Product Bulletin:

February 8, 2019

Subject: Top Rail Change for Plate Trailers

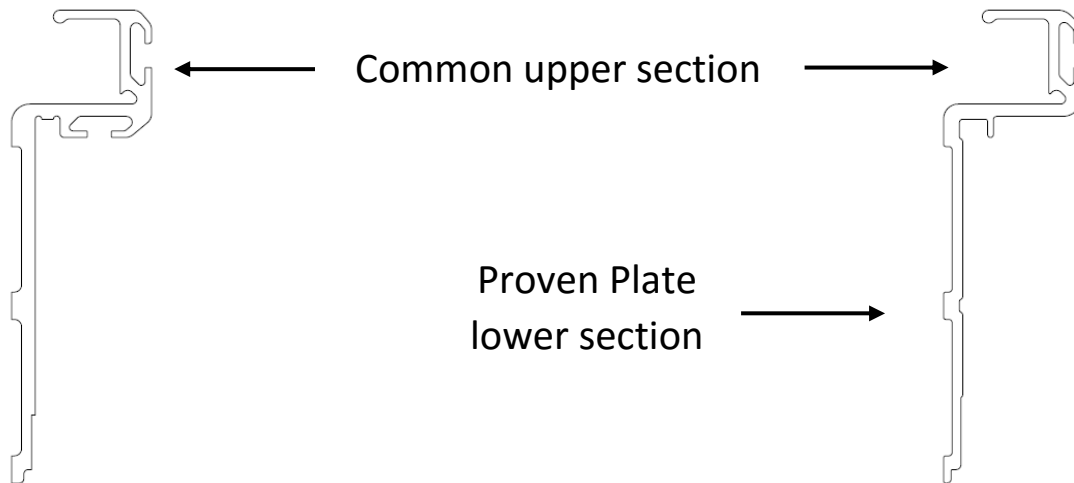
In 2017, Stoughton introduced a newly designed top rail that was interchangeable between plate and sheet & post trailers. After careful consideration we have decided to return to having unique top rails for each model. The sheet & post trailers will maintain the current top rail design. The new top rail for plate trailers is a hybrid between the proven lower section combined with the new upper section containing the common T-Bolt slot for roof bow attachment. The redesigned roof bow, also released in 2017, will continue to fit both top rails. Going forward:

Sheet & Post Top Rail: Current design 02-28844-624-50

Plate Trailers Top Rail: Hybrid design plate trailers 02-30306-624-50

This new plate trailer profile will be applied to the front wall upper rail as well for all dry vans. The Stoughton Parts Sales part number will be **02-30306-090-19**.

02-28844-624-50

Current Sheet & Post Rail

02-30306-624-50

Plate Trailers Only

Cannot be used on Sheet & Post
